Flight Procedures Cover Page	Task Action: FLIGHT CHECK	Task Type: STAR	Estimated Chart Date: 06/12/2025	APWS Task ID: 2824DD55B8AB4917820167103722CCE4	APWS Project ID: 35239729C23A4E65B183831F0CBB17F2
Procedure: STAR CSTAL THREE (RNAV) MIAMI FL KMIA		Enroute: YES	Specialist: Owens, Westley		Agreement Number:
Airport ID: KMIA			Airport City: MIAMI		State: FL
Facility ID:	Facility Type:	Flight Inspection Remark Type: New FC Slot			
<div>Procedure Comments: CHANGED FIX NAME "KAIZR" TO "CADEE" ADDED HOLDING AT CADEE. CONTACT: ERIC SUSKI, AJV-A431, (405) 954-7331.</div> <div><div>12/16/2024</div><div><div>QUALITY 14 CHECKED</div><div>QUALITY 38 CHECKED</div></div></div>

FIPC DME/DME FORM							
PROCEDURE: CSTAL (RNAV) THREE ARRIVAL			AIRPORT NAME: MIAMI INTL		AIRPORT ID: KMIA	SPECIAL CONTROL NO: AG-12-186-24	
FAC ID: CSTAL3		CITY: MIAMI			ST: FL	ORIG CHART DATE: 06/12/2025	
DFL TYPE: PROC/D	THIRD PARTY: <input type="checkbox"/> YES	EST. TIME ON SITE: 1.0	REIMB. NUMBER:		PTS TASK ID: 2824DD55B8AB4917820167103722CCE4		
PREFLIGHT NOTES							
REVIEWER: eric l geyer					DATE: 01/23/2025		
COMMENTS: Can be completed in the FMS: Check waypoint CADEE replaced KAIZR (same location). Check new

BNFSH to OTION Segment

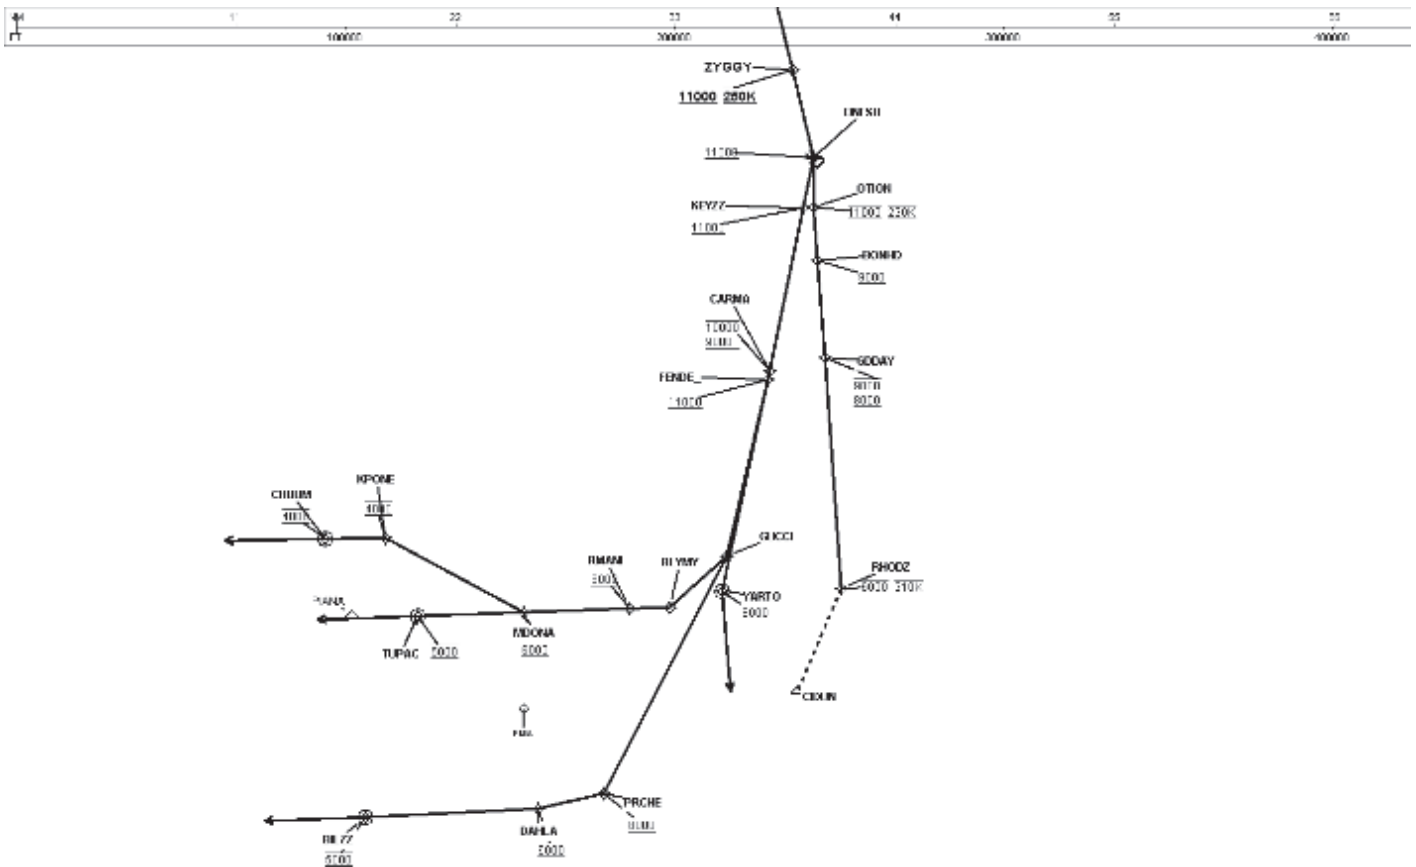
“RSO179: [Approval Required] The length of the leg from BNFSH to OTION is 2.477851816357096 NM. This leg must be at least 4.0 NM long due to deceleration from 250.0 KIAS to 230 KIAS between 11000.0 ft. MSL to 11000.0 ft. MSL.”

The segment with the restrictions of At or Above (AOA) 11000 250KIAS at ZYGGY followed by AOA 11000 at BNFSH then At 11000 230KIAS at OTION requires a 4 NM length, per the 8260.3E paragraph 2-2-10 a, for a reduction of 10- 40Kts. The deceleration required by the BNFSH-OTION segment is 20Kts. The reduction from 250Kts to 230Kts from ZYGGY to OTION is 6.96 NM. The KMIA CSTAL STAR was tested in simulation by American Airlines and in the Mike Monroney flight simulators and the deceleration of 20Kts over 2.48 NM did not have an adverse effect of the descent profile.

Consideration was given to removing and or changing the restrictions at BNFSH and or OTION. However, to allow aircraft to be configured for the segments following OTION the restrictions remained unchanged after simulation proved losing 20 KIAS over 2.48 NM was not an impediment to the safety or profile of the procedure.

OTION to BONHD Segment

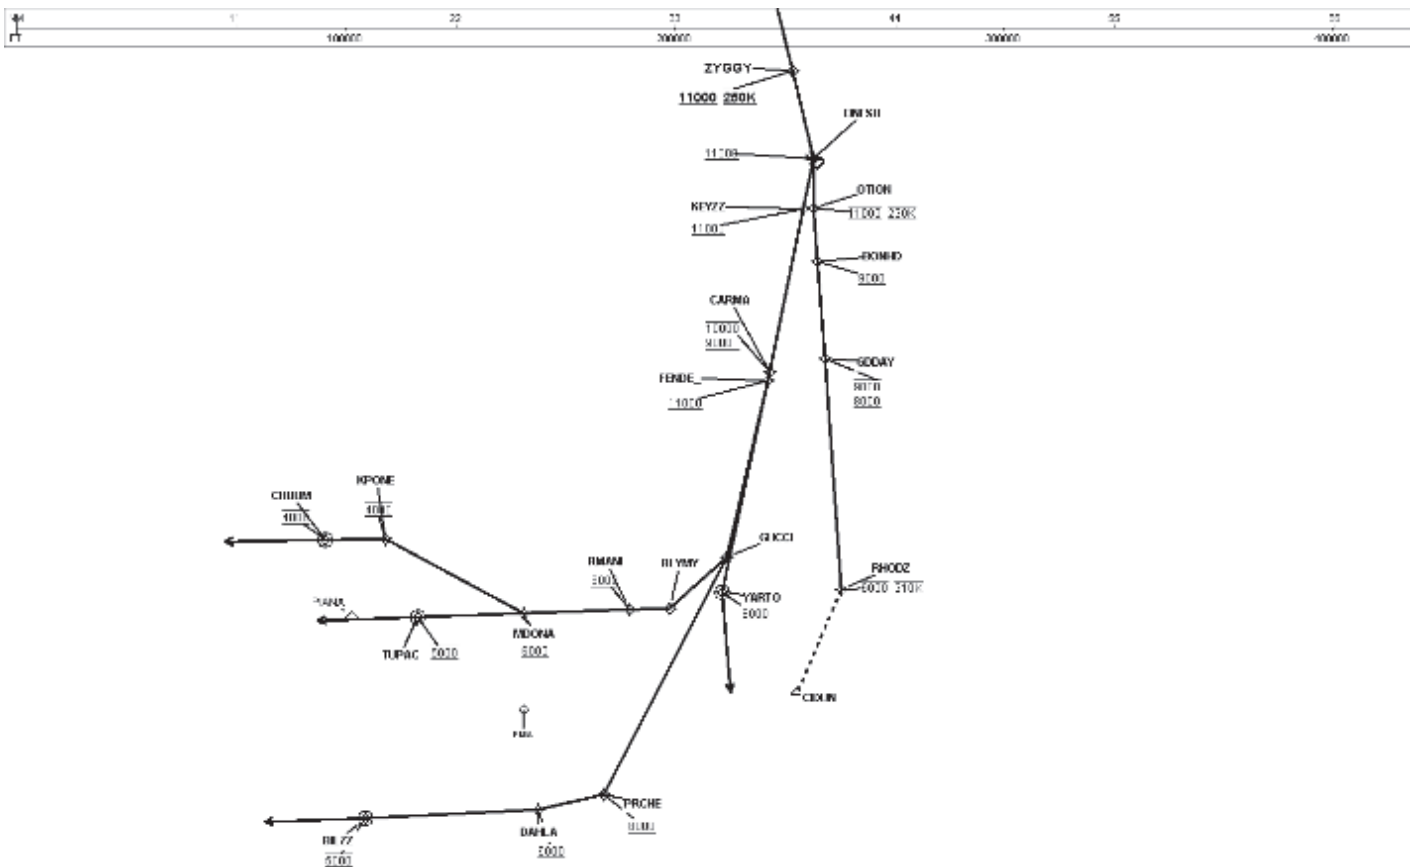
RSO144: [Approval Required] The Descent Gradient (747.91) from OTION to BONHD is greater than the Maximum Permissible Descent Gradient (324.0).

A computed descent gradient value from OTION to BONHD of 747.91 ft. per NM resulted from the descent gradient being calculated from descending from the restriction of At 11000 and 230KIAS at OTION to cross BONHD At or Above 9000 (9000 used) over a distance of 2.67 NM. The restriction after BONHD is at GDDAY, a block altitude, 8000-9000, followed by RHODZ, at 6000 and 210KIAS.

The distance from OTION to GDDAY is 7.53NM, the distance from GDDAY to RHODZ is 11.50NM (7.53+11.50=19.03NM) and using a descent gradient of 324ft/NM a total distance of 17.43NM is required. An aircraft crossing OTION at 11000 and crossing GDDAY between 8000 - 9000 descending at 324 ft. per NM places an aircraft over BONHD (at or above 9000) at 10135. The calculated descent gradient from OTION to RHODZ is 294ft. per NM.

Consideration was given to removing and or changing the restrictions at OTION, BONHD, GDDAY and RHODZ. However, due to airspace constraints and traffic flows it was decided that the restrictions are necessary to prevent aircraft from entering adjacent airspace, prevent confliction from other traffic and procedures, and reduce ATC workload due to required coordination, (point outs).

PRCHE to DAHLA Segment

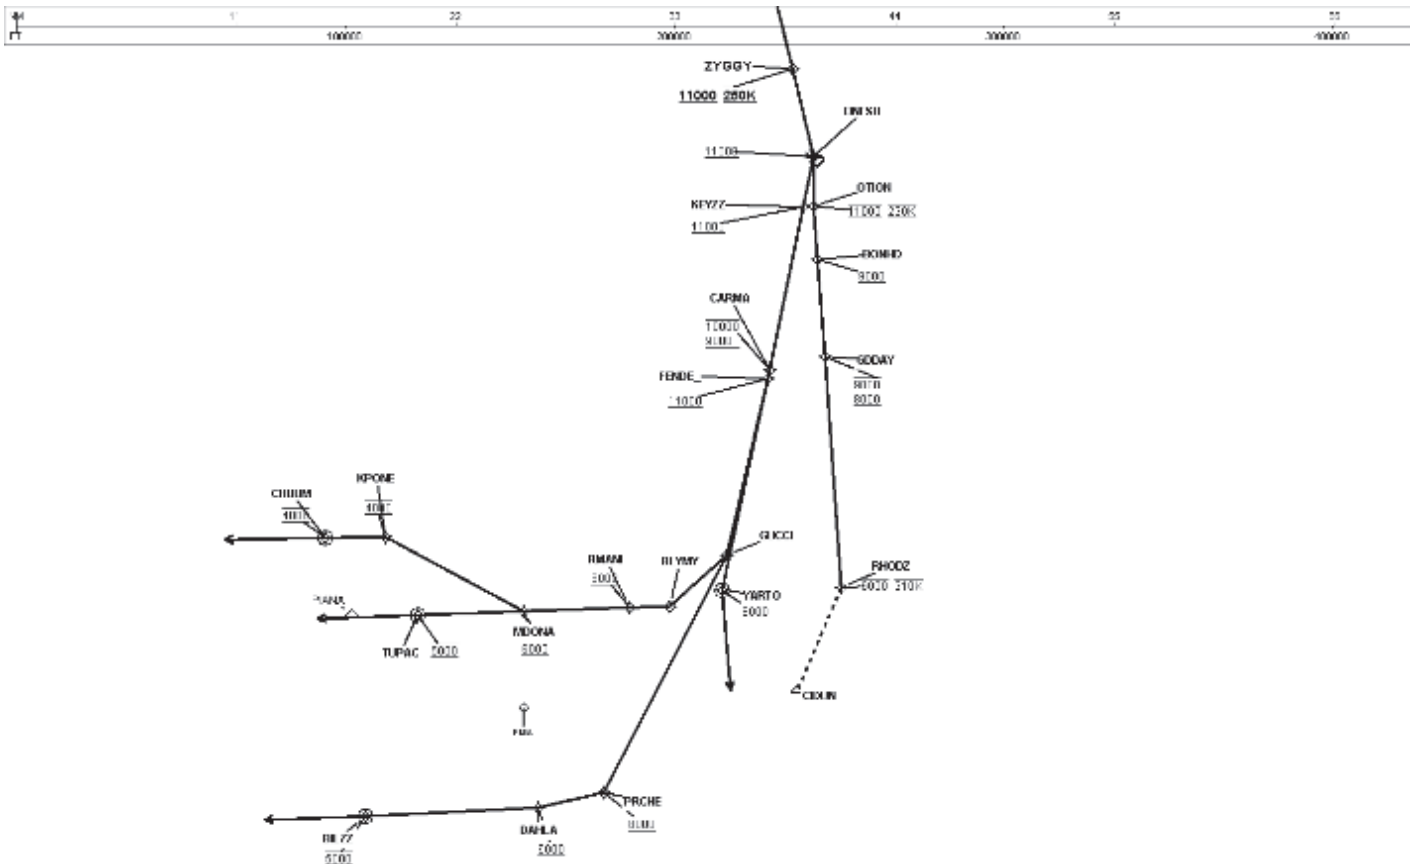
RSO144: [Approval Required] The Descent Gradient (596.22) from PRCHE to DAHLA is greater than the Maximum Permissible Descent Gradient (318.0).

A computed descent gradient value from PRCHE to DAHLA of 596.22 ft/NM resulted from the descent gradient being calculated from descending from the restriction of AOA 8000 at PRCHE (8000 used) to cross DAHLA AOA 6000 (6000 used) over a distance of 3.35 NM. The next restriction after DAHLA is BILZZ at 5000. The distance from PRCHE to BILZZ is 12.05 NM and using a descent gradient of 318 ft. per NM a total distance of 9.44 NM is required. An aircraft is permitted to cross DAHLA AOA 6000 and cross BILZZ at 5000. The calculated descent gradient from PRCHE to BILZZ IS 249ft. per NM. Descending at 249ft. per nm places the aircraft at 7165 over DAHLA.

Consideration was given to removing and or changing the restrictions at PRCHE and/or DAHLA. However, due to airspace constraints and traffic flows it was decided that the restrictions are necessary to prevent aircraft from entering adjacent airspace, prevent confliction from other traffic and procedures and reduce ATC workload due to required coordination, (point outs).

RMANI to MDONA Segment

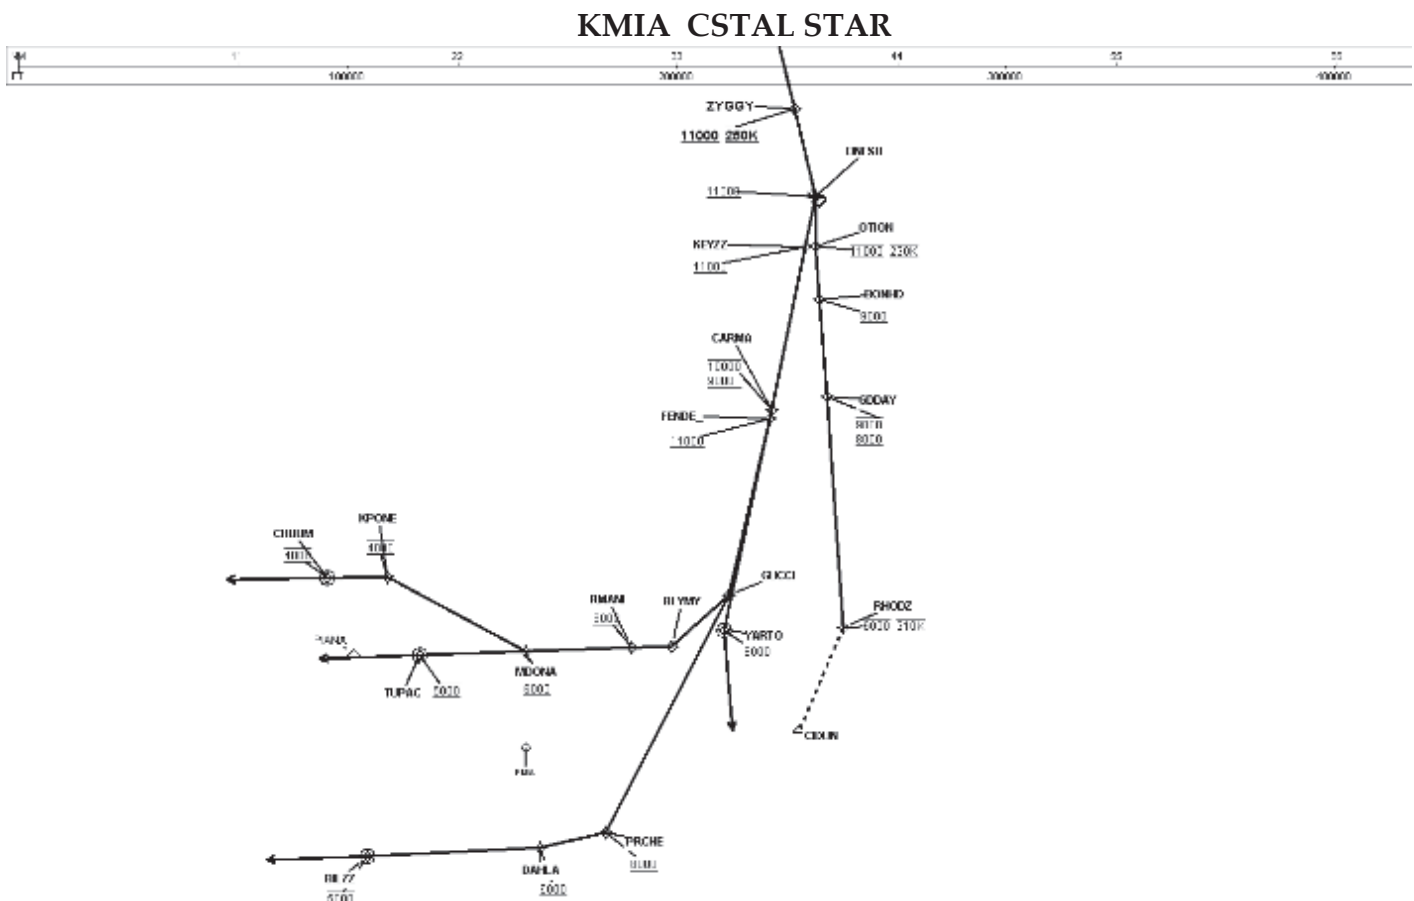
A computed descent gradient value from RMANI to MDONA of 377.60 ft. per NM resulted from the descent gradient being calculated from descending from the restriction of At or Above (AOA) 8000 at RMANI (8000 used) to cross MDONA AOA 6000 (6000 used) over a distance of 5.29 NM. The next restriction after MDONA is TUPAC at 5000 or KPONE at 4000. The distance from RMANI to TUPAC is 10.60 NM and using a descent gradient of 318 ft/NM a total distance of 9.44 NM is required. RMANI to KPONE is 13.14 NM and using a descent gradient of 318 ft. per NM a total distance of 12.58 NM is required. An aircraft is permitted to cross MDONA AOA 6000 and cross KPONE at 4000. Descending at 318 ft. per NM places an aircraft descending from 8000 over RMANI across the restriction at MDONA (AOA 6000) at 6318. The calculated descent gradient from RMANI to TUPAC IS 283 ft. per NM and RMANI to KPONE is 304 ft. per NM.
